ADDENDUM TO THE CONTRACT

Gastineau Elementary School Renovation

Contract No. E11-137

ADDENDUM NO.: FIVE

Landscape Details

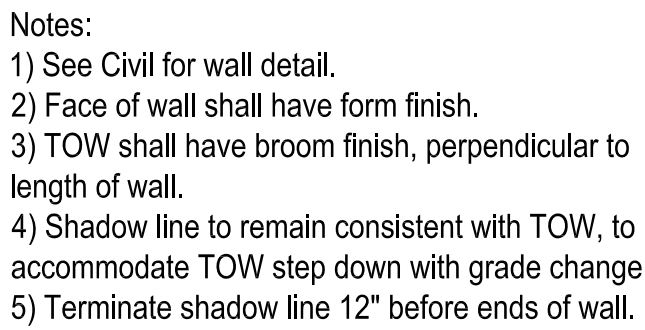
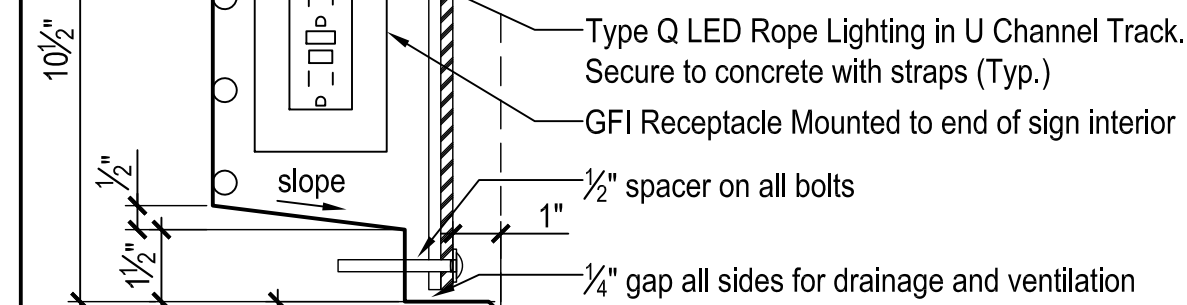
- Item No. 6 Sheet L107 – **Add** (1) stockpiled and transplanted AR street tree along 3rd Street 15’ east of new concrete sidewalk.
- Item No. 7 Sheet L503 –Landscape Details. **Delete** and **replace** with the attached Sheet L503.
